Subject: AP1000 Response to Request for Additional Information (SRP 7)

AP1000 TECHNICAL REPORT REVIEW

RAI Response Number: RAI-SRP7.1-ICE-10
Revision: 1

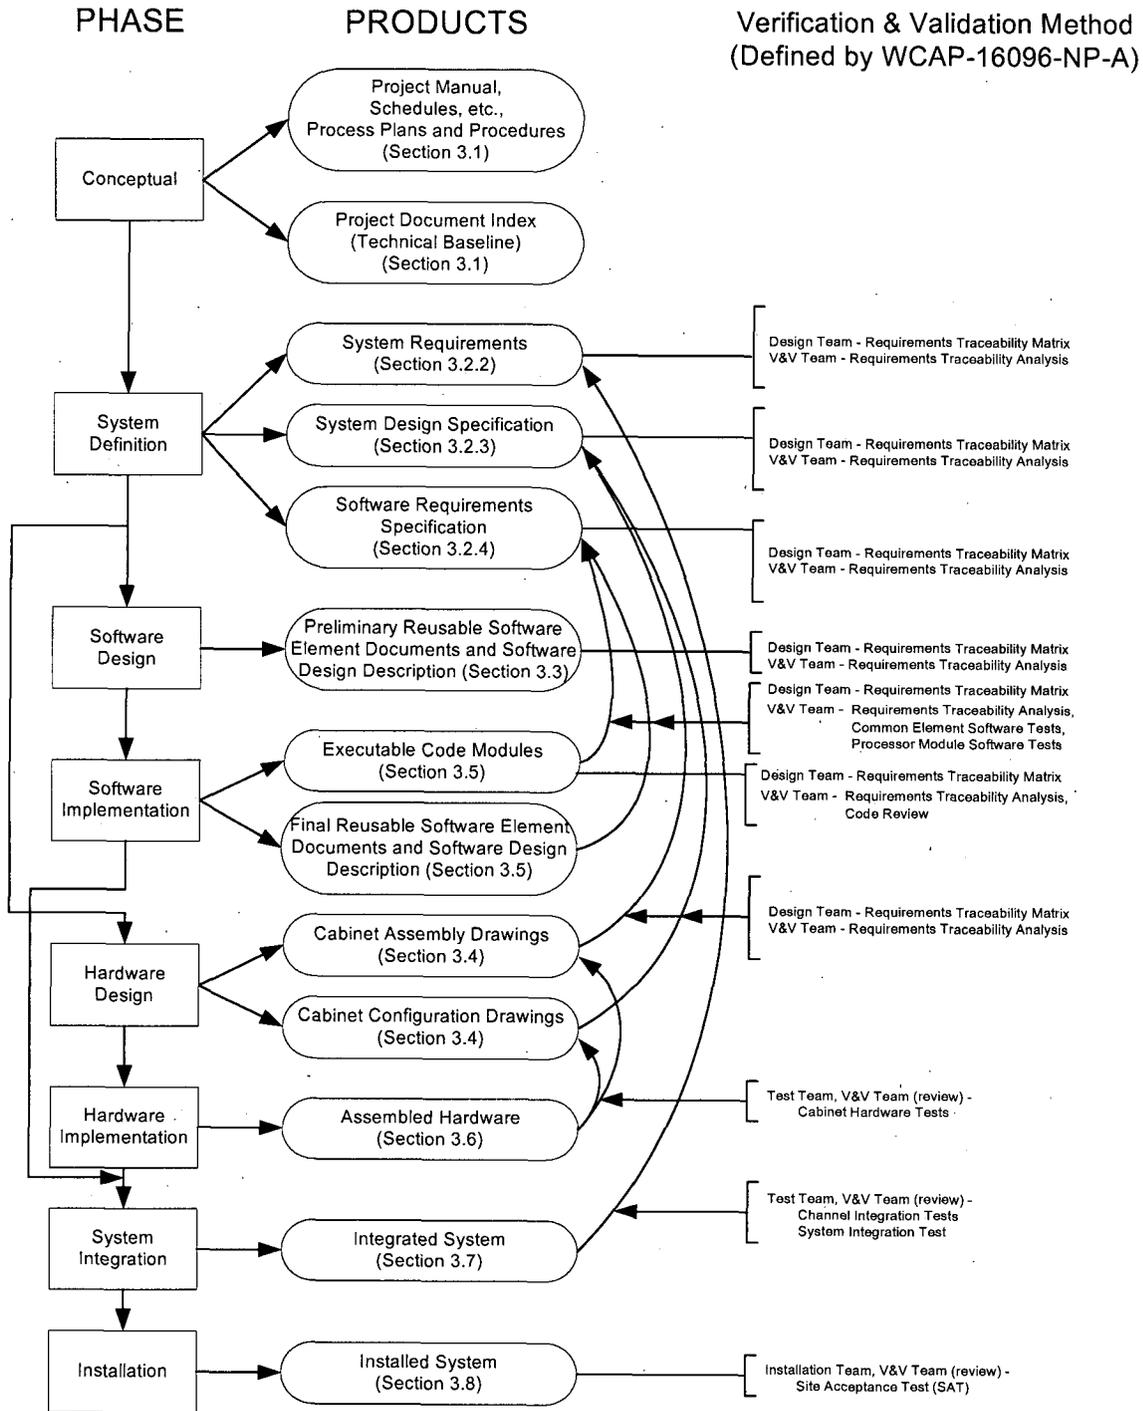
During the January 2009 meetings between Westinghouse and the NRC, the NRC expressed concerns about what appears to be a changed direction on the Westinghouse application of requirement traceability analysis between the Rev. 0 and not-yet-docketed Rev. 1 of WCAP-15927. The concerns stem from the revision to Figure 1, "Development Process," of WCAP-15927.

The V&V method applied to the life cycle phases (i.e., the side note on Figure 1 of WCAP-15927), is not detailed in WCAP-15927. Therefore, without the benefit of textual description of the lifecycle V&V activities, the figure does not provide enough detail to draw a conclusion on the Westinghouse approach to the requirement traceability process. This approach is defined in the SPM.

The Westinghouse approach to requirement traceability has not changed from Rev. 0 of WCAP-15927 and is described in the SPM. For clarification purposes, however, Westinghouse will revise the figure as depicted below to better describe the approach to requirement traceability, and reference the SPM for more details.

The independent V&V (IV&V) team has always been tasked with the requirement traceability analysis. However, the design team provides the Requirement Traceability Matrix (RTM) as input to IV&V team for analysis. If the IV&V team was also tasked with developing the RTM, there would be nobody to perform a third-party review of the work produced, and the purpose of having IV&V in the first place would be jeopardized.

WCAP-15927, Rev. 2 will be submitted to the NRC with an updated figure as described in the Rev. 1 response of this RAI.
